Project	<b>IEEE 802.16 Broadband Wireless Access Working Group</b> < <a href="http://ieee802.org/16">http://ieee802.org/16</a> >	
Title	<b>Addendum to Recirculation Ballot #13a Comment on WirelessMAN-SCa Framing</b>	
Date Submitted	<b>2003-12-29</b>	
Source(s)	Brian Eidson Conexant Systems, Inc. 9860 Scranton Rd, Suite 1000 San Diego, CA 92121 USA	Voice: +1 858 713-4720 Fax: +1 858 713-3555 <a href="mailto:brian.eidson@conexant.com">mailto: brian.eidson@conexant.com</a>
Re:	IEEE 802.16-03/51r3 and IEEE P802.16-REVd/D2-2003	
Abstract	Supports a multi-item technical comment on WirelessMAN-SCa burst framing that the author has submitted for Recirculation Ballot #13a. This reply comment is nominally associated with Comment #456, with some connection to Comment #248.	
Purpose	To provide text and editing instructions for the comment referenced by author's Commentary submission.	
Notice	This document has been prepared to assist IEEE 802.16. It is offered as a basis for discussion and is not binding on the contributing individual(s) or organization(s). The material in this document is subject to change in form and content after further study. The contributor(s) reserve(s) the right to add,

Figure 177—STC dual blocks without UWs

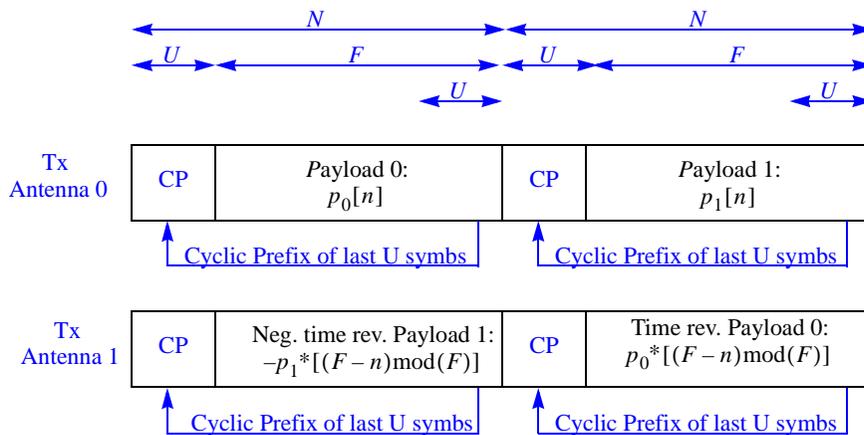
Figure 177 illustrates the baseline framing structure for STC transmit multiplexing. This is cyclic-prefix-based frame structure, with  $U$ -symbol cyclic prefixes (CPs), and  $F$ -symbol payload repetitions—chosen to facilitate efficient processing at the receiver based on fast Fourier transform (FFT). Note that although the CP is not composed of Unique Words, the length of the CP,  $U$ , shall be the same as the Unique Word length being used by the burst profile. Observe that the payload portions of Figure 177 reflect the STC antenna multiplexing format described in Table 164 for Transmit Antennas 0 and 1. As illustrated in Figure 178, Note that a Unique Word may be inserted within Payloads 0 and 1 to facilitate decision feedback equalization at the receiver—the use of frequency domain equalizers with time domain decision feedback taps..

Figure 178—STC dual blocks with UWs

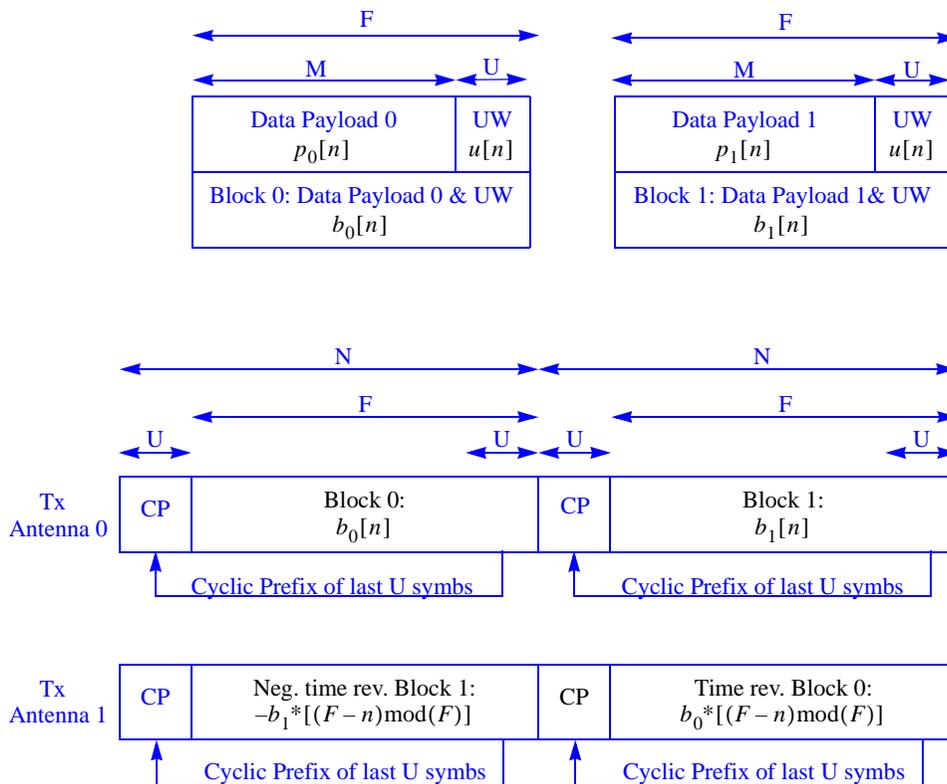
Figure 178 illustrates another burst profile which explicitly uses Unique Words, rather than a repetition of the payload data, to generate CPs.

$F$ , the length of an STC block, is a burst profile parameter. The choice of the burst profile for the paired blocks, i.e., the scheme illustrated in Figure 177 or the scheme illustrated in Figure 178, is also a burst profile parameter.

Figure 179—STC burst set preamble

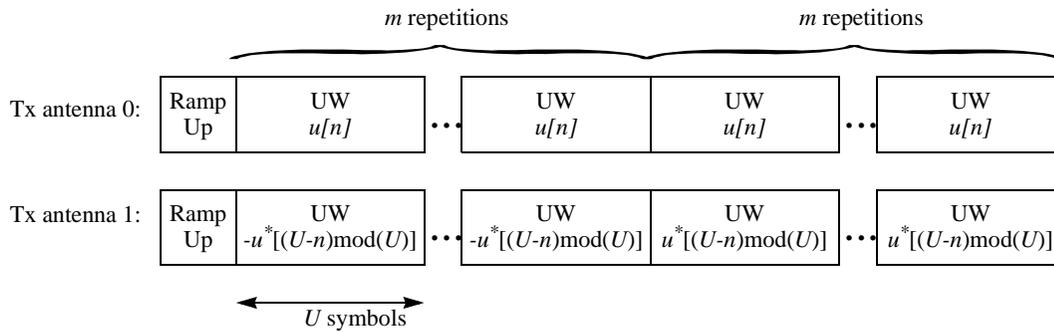
Figure 179 illustrates that the burst set preamble shall be used for burst sets utilizing STC transmit diversity encoding. The number of Unique Word blocks composing a STC burst set preamble is a parameter of the Burst Set Delimiter Extended IE (for downlink) or burst profile (for uplink). However, since two channels shall be estimated, the total number of UWs used to construct an STC burst set preamble shall be twice the parameter value specified.

The preamble structure of Figure 179, minus the ramp up symbols, may also be inserted within a transmission, as a group of contiguous Pilot Words to assist in channel estimation and updates within a burst set. In such an instance, this contiguous pilot symbol structure is considered external to the paired STC payload data blocks illustrated in Figure 177, although the pilots may appear after every  $V^{\text{th}}$  paired payload block, where  $K$  is an integer greater than or equal to 1. The pilot word repetition interval, and the number of UWs composing a pilot word are parameters of the Burst Set Delimiter Extended IE (for downlink) or the burst profile (for uplink) defining the start of the STC-encoded burst set.
